UNITED STATES PATENT AND TRADEMARK OFFICE

APPLICATION NO.	FILING DATE	FIRST NAMED INVENTOR	ATTORNEY DOCKET NO.	CONFIRMATION NO.
10/517,742	07/20/2005	Hartmut Ressel	10191/3901	6162
26646	7590	07/05/2006	EXAMINER	
KENYON & KENYON LLP ONE BROADWAY NEW YORK, NY 10004			VU, BAO Q	
			ART UNIT	PAPER NUMBER
			2838

Office Action Summary

DETAILED ACTION

Fig. 5

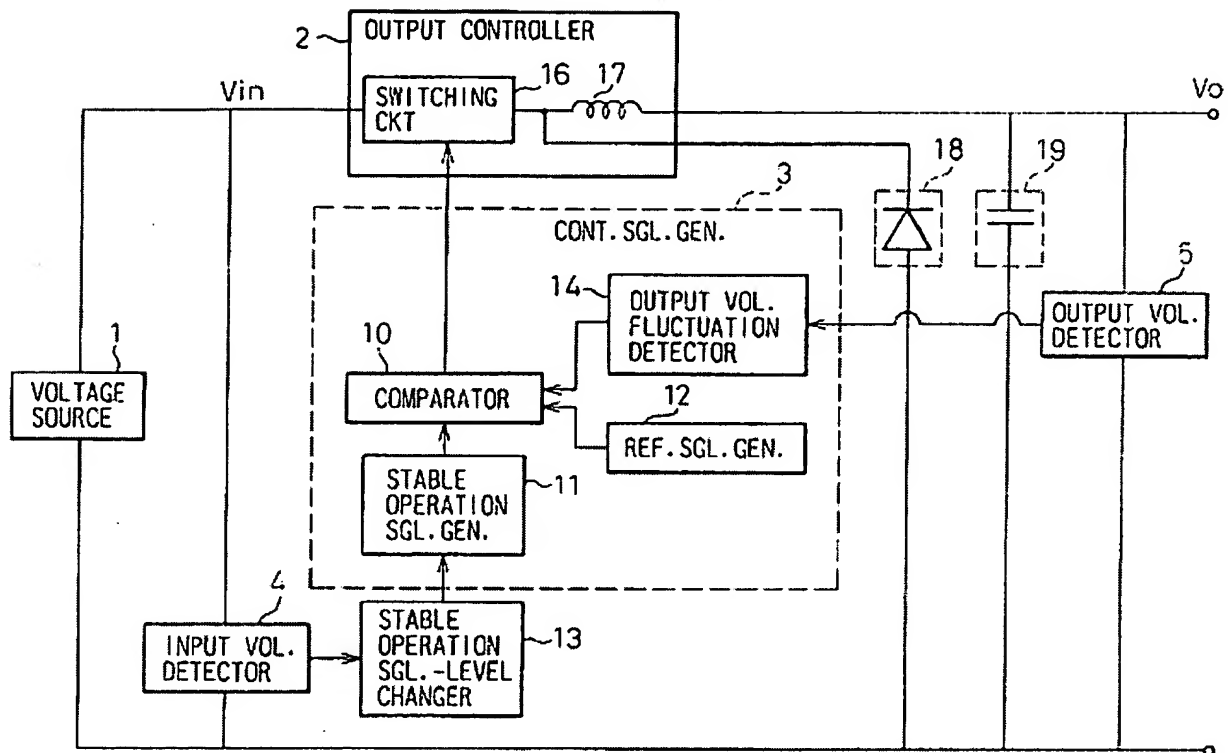
4. Claims 17, 18, 20-30, 32-34 are rejected under 35 U.S.C. 102(b) as being clearly anticipated by Saeki et al. (USP 5,572,112). Saeki discloses the claimed invention a switch device (16), a filtering circuit (19), a feedback device (5), a controllable amplifier (10), and a compensation signal-generating device (11). See figure below
